Project	IEEE 802.16 Broadband Wireless Access Working Group < http://ieee802.org/16 >	
Title	Transport connection establishment of a MS served by a RS in moving BS mode	
Date Submitted	2007-07-05	
Source(s)	Hang Zhang, Peiyong Zhu, Mo-Han Fong, Wen Tong, David Steer, Gamini Senarath, G.Q. Wang, Derek Yu, Israfil Bahceci, Robert Sun and Mark Naden Nortel 3500 Carling Avenue Ottawa, Ontario K2H 8E9	Voice: +613-763-1315 E-mail: wentong@nortel.com Voice: +613-765-8983 E-mail: pyzhu@nortel.com
Re:	IEEE 802.16j-07/019: "Call for Technical Comments Regarding IEEE Project 802.16j"	
Abstract	For a RS operates in moving BS mode, the service flow of a MS is managed by MR-BS and service flow ID (SFID) is assigned by a MR-BS. However, the CID of corresponding transport connection is assigned by the MS's serving RS.	
Purpose	To incorporate the proposed text into the P802.16j Baseline Document (IEEE 802.16j-06/026r4)

Transport connection establishment of a MS served by a RS in moving BS mode

Figure1. Transport connection setup via a RS in MBS mode (MR-BS initiated)

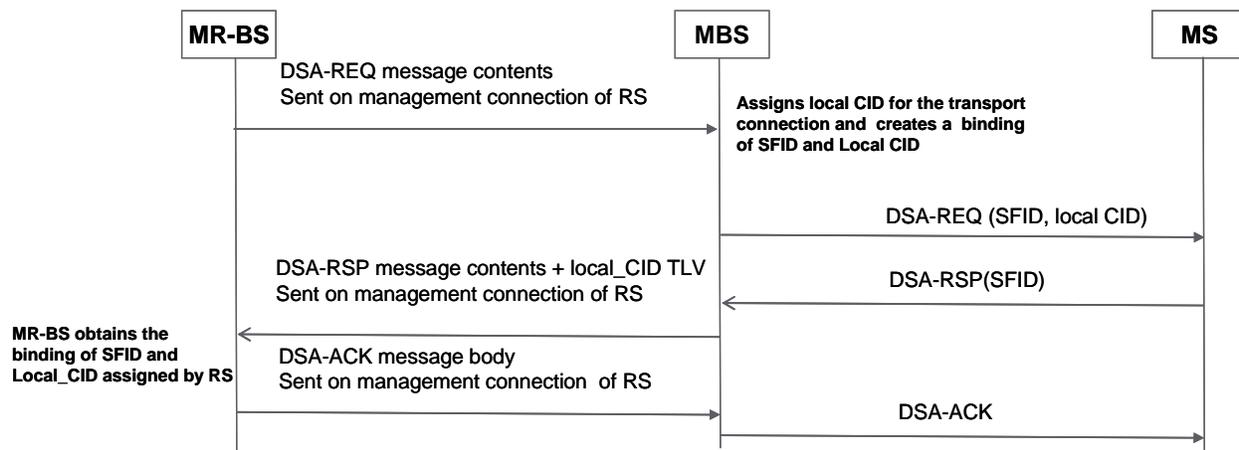
For MR-BS initiated service flow setup, the MR-BS sends the contents of DSA-REQ message using RS_MSG_Relay-REQ message over management connection of the RS (refer to contribution “Relaying of Messages of MSs served by RS in moving BS mode”). After the RS receives this message, the RS shall assign a local CID (L_CID) to the transport connection to be established for this service flow and creates binding between this SFID and this L_CID. The RS shall then send the DSA-REQ message to corresponding MS with the assigned local CID. After RS receives the DSA-RSP message from the MS, the RS shall relay the contents of this message as well as the assigned local CID TLV using RS_MSG_Relay-RSP message to MR-BS over its management connection.

After this MR-BS receives this RS_MSG_Relay-RSP message, the MR-BS creates a binding between SFID and local CID assigned by this RS.

Figure 2. Transport connection setup via a RS in moving BS mode (MS initiated service set up).

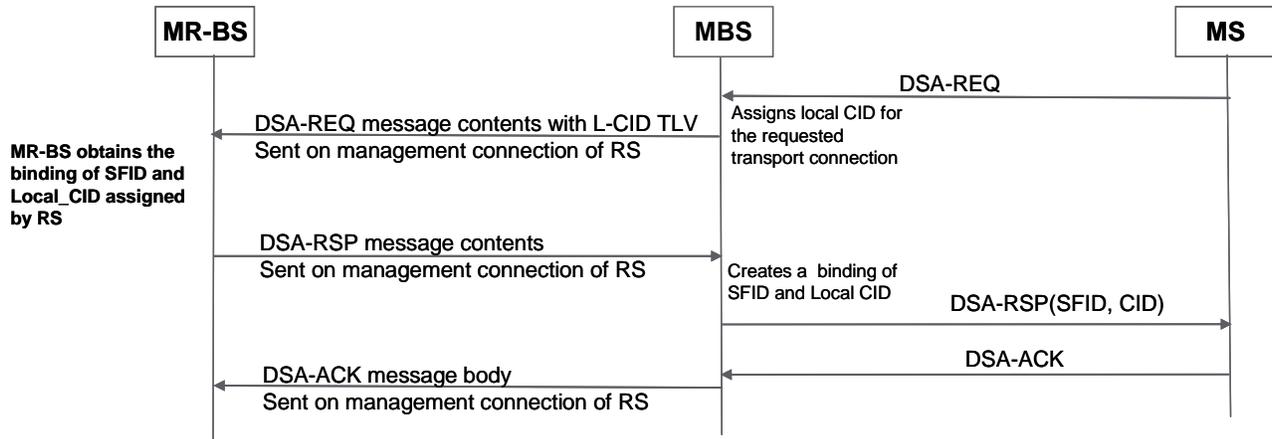
For MS initiated service flow setup (refer to Figure 2), after a RS receives DSA-REQ from a MS, the RS shall

assign a local CID to this potential UL service flow and relay the contents from the received DSA-REQ message as well as the local assigned CID to the MR-BS. The binding between the UL service flow and the local CID is established by MR-BS. The MR-BS shall use RS_MSG_Relay RSP message to carry the contents of DSA-RSP message and send this message the RS. The RS then creates the DSA-RSP message to the MS. The RS crates a binding between the SFID and the local CID.
